BENGALLA MINE

Development Consent Modification 4 Response to Submissions

for
Bengalla Mining Company Pty Ltd
May 2018

MOD4 Conceptual Year 24 Mine Plan

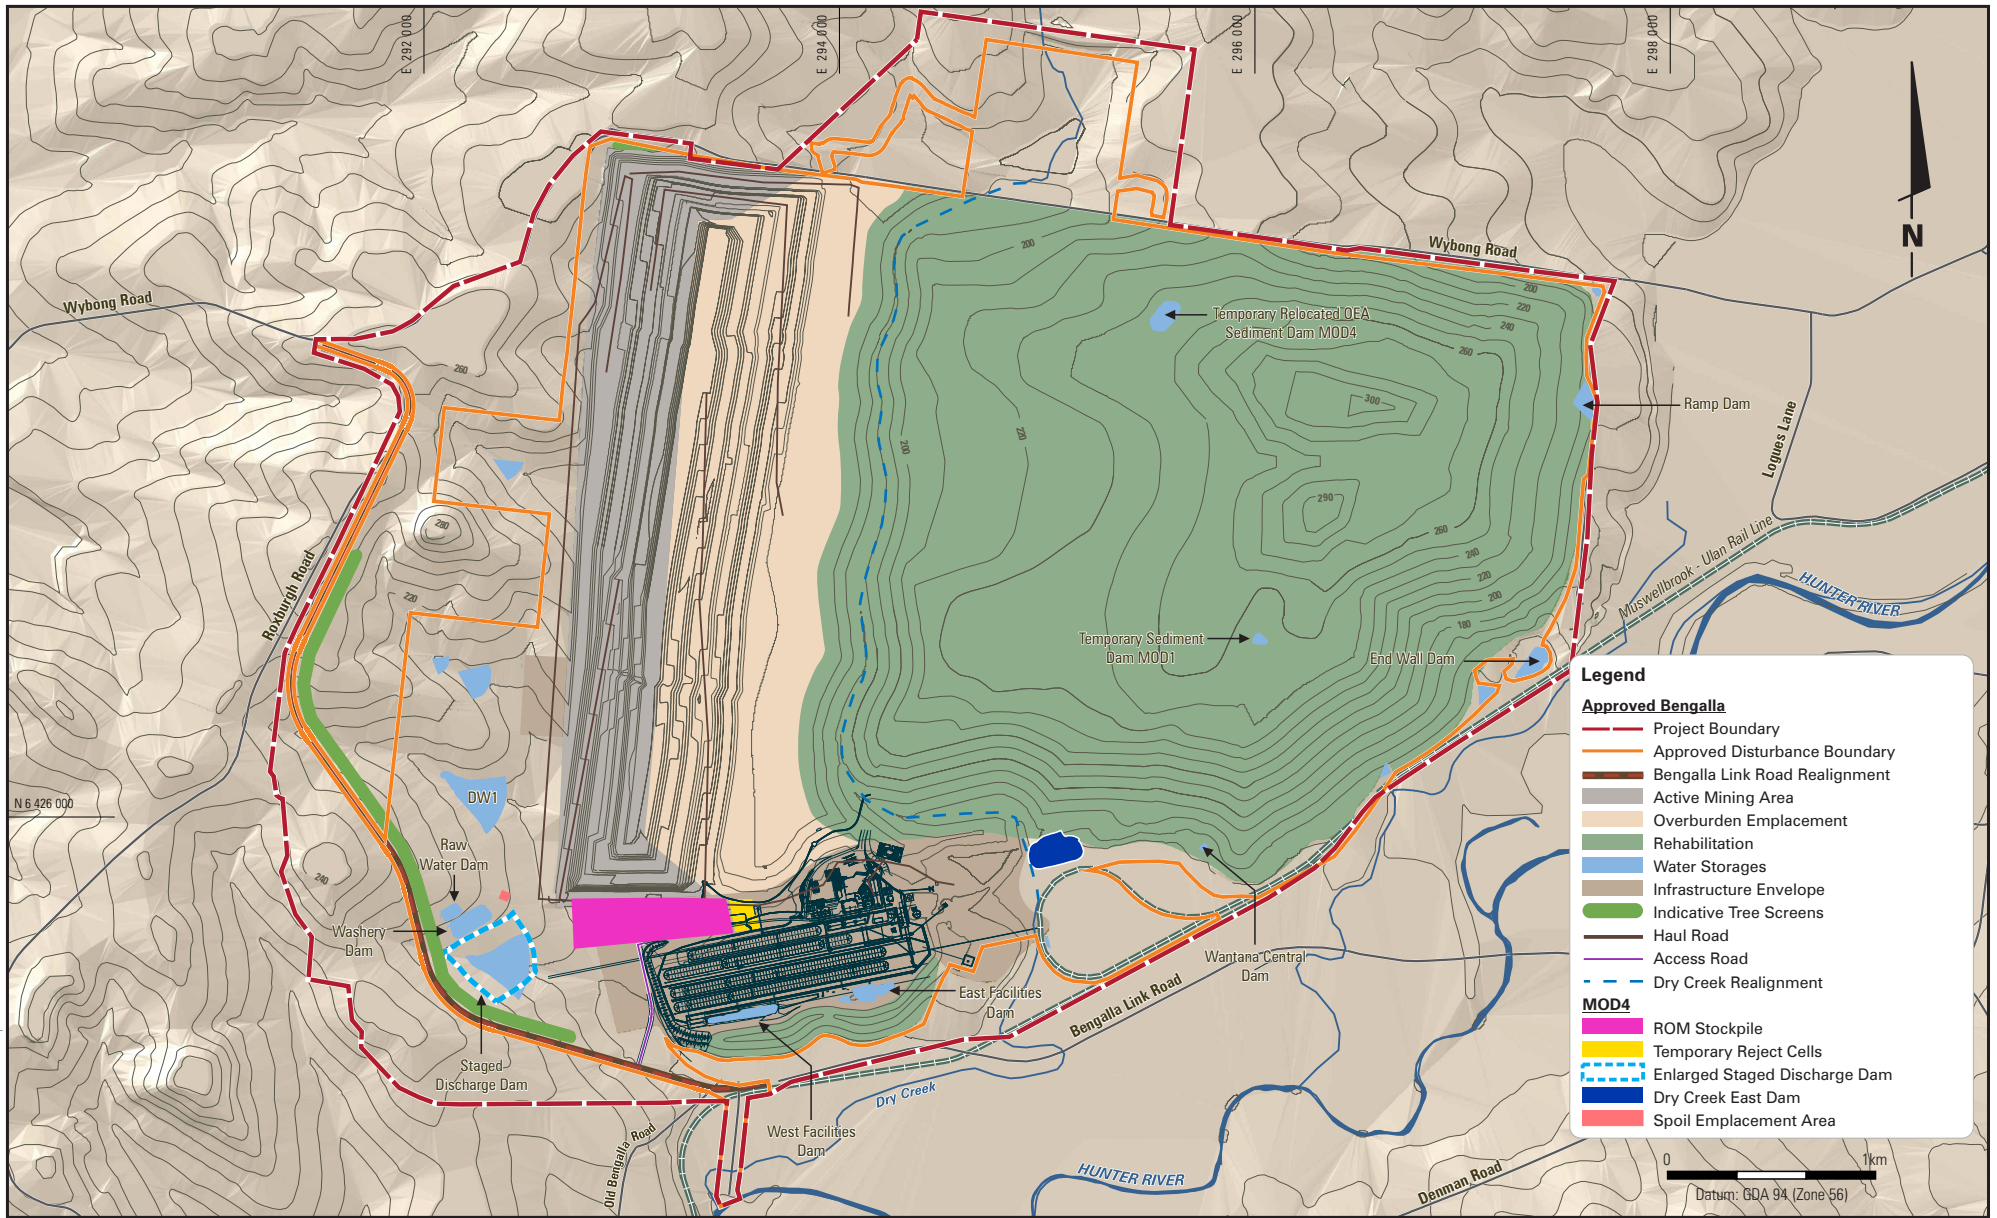
DPE requested by email: *“a figure including the currently approved location of the Temporary OEA Sed Dam and its proposed location in Year 24.”*

See **Figure 1**.

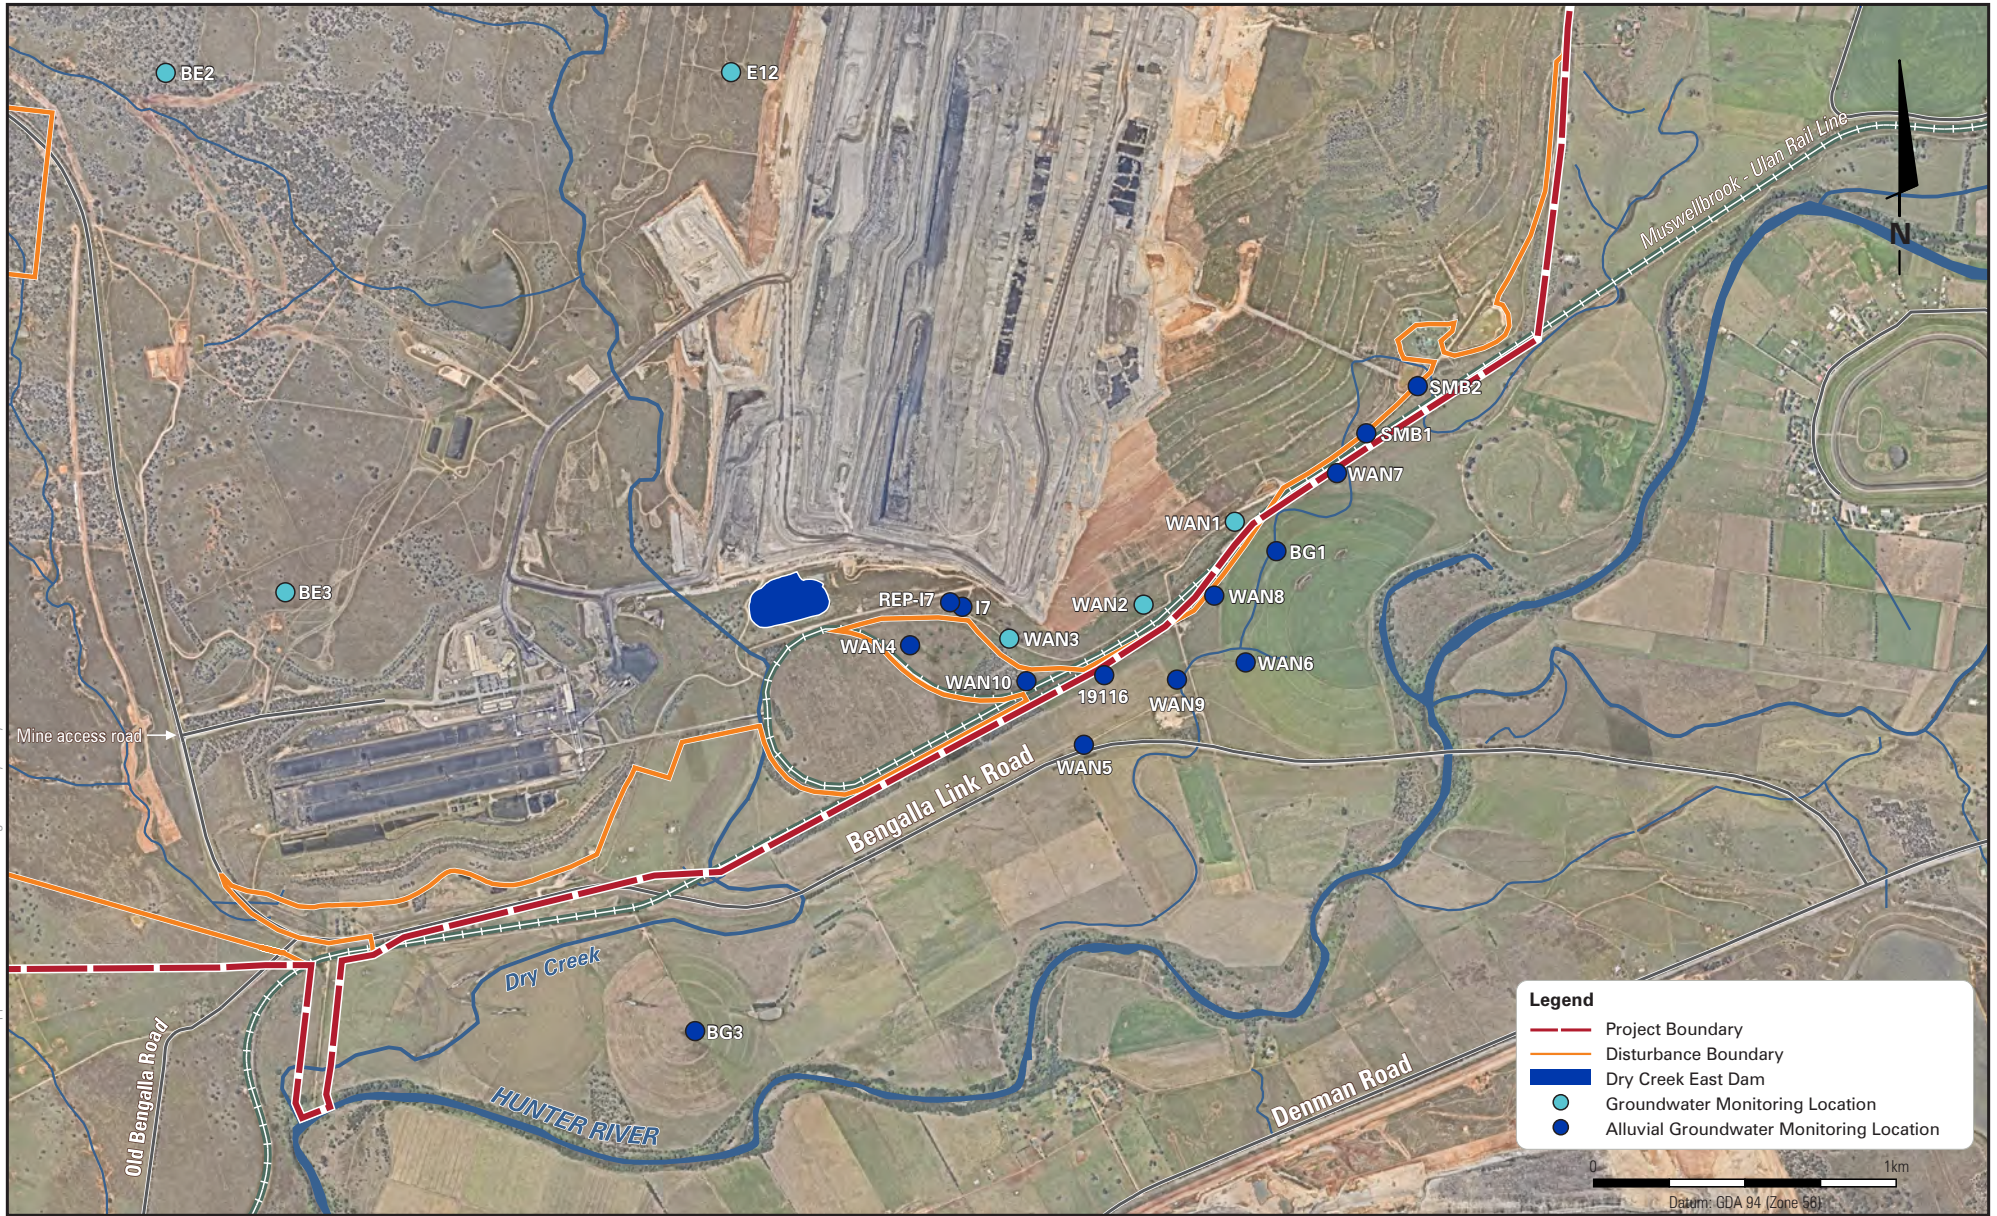
- 1 That the proponent be required to install a shallow alluvial monitoring bore down gradient of the new Dry Creek East Dam and include in the Water Management Plan.*
- 2 That the proponent be required to update the Water Management Plan in consultation with Dol Water."*

Figure 2 shows the approved alluvial monitoring bores that are currently in the vicinity of the proposed Dry Creek East Dam. These bores are monitored monthly for water level and quality as outlined in the approved WMP, and will continue to be monitored post the construction of Dry Creek East Dam. The existing monitoring program is sufficient to identify any potential groundwater impacts from the construction and operation of the Dry Creek East Dam. The WMP modified from time to time will be updated in consultation with required government departments should MOD4 be approved.

Figure 2.1 Location of test pit TP12

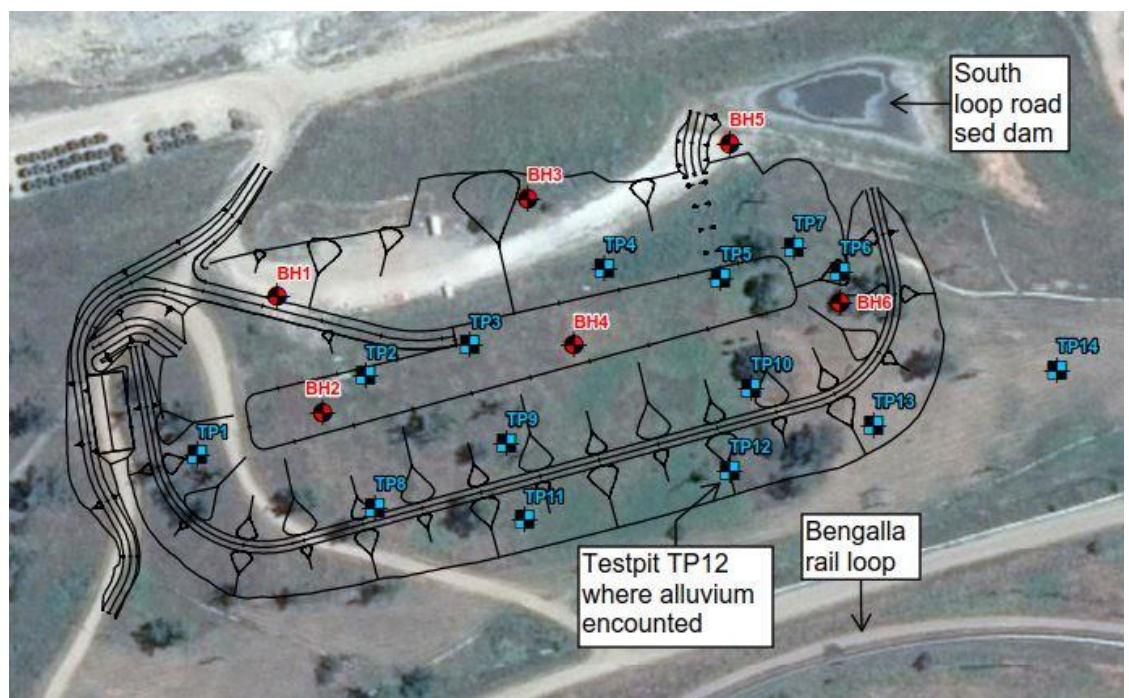
“The modification proposes to build a new dam, called the Dry Creek East dam immediately north of the rail loop. The purpose of this dam is to initially hold mine water, and in time capture runoff from the rehabilitated areas. It is to remain post closure. Some of this dam is located on the Hunter River alluvium. Due to the location of the dam on the alluvium and the minimal studies provide [sic] in the Application, Council is concerned it may leak and pollute the alluvium with saline mine water.

- i. The Dry Creek East dam should not be located on any part of the alluvium;*
- ii. Further studies are to be undertaken to determine the likelihood of the dam leaking saline water and provide recommendations on how this risk can be avoided and the alluvium not polluted with mine water;*
- iii. Should the building of the dam be approved in its current location, Council be provided with monitoring results with the purpose of satisfying Council that the water quality within the alluvium is not being compromised by the dam.*

During test pitting investigations of the proposed Dry Creek East Dam area, one test pit out of 14 identified clay alluvial type material, to a depth of 200mm, and this test pit was at the outside edge of the dam wall (see **Figure 2.1** in **Appendix A**).

Figure 2.2 Dam cross section and alluvium

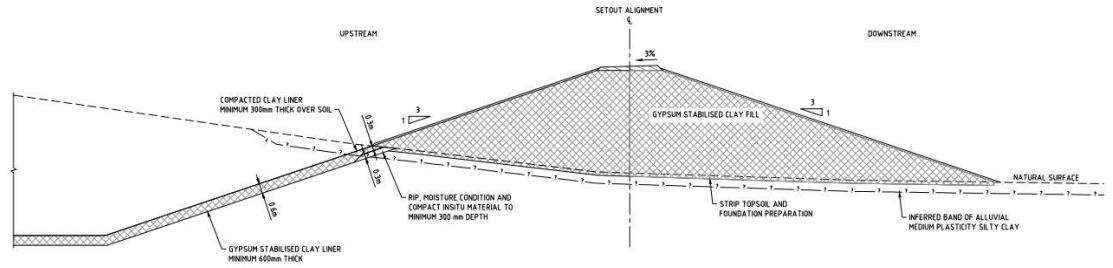
- “1. Council raised concerns over the proposed clay liner. Provide additional information to demonstrate that the clay liner is adequate to prevent seepage to the alluvium.
2. Please address Crown Lands and Water’s comments that, after Year 15, clean water dams would exceed the site’s harvestable rights.
3. In comments on Mount Pleasant Mod 3, the EPA raised concerns that water could discharge from Mount Pleasant to the Bengalla Coal Mine. Please advise what measures are in place to prevent discharges from Mount Pleasant impacting the Bengalla Coal Mine Water Management System.”

A cross section of the dam showing the location of the alluvial material and the storage is shown in Figure 2.2 below. This figure includes the clay liner.
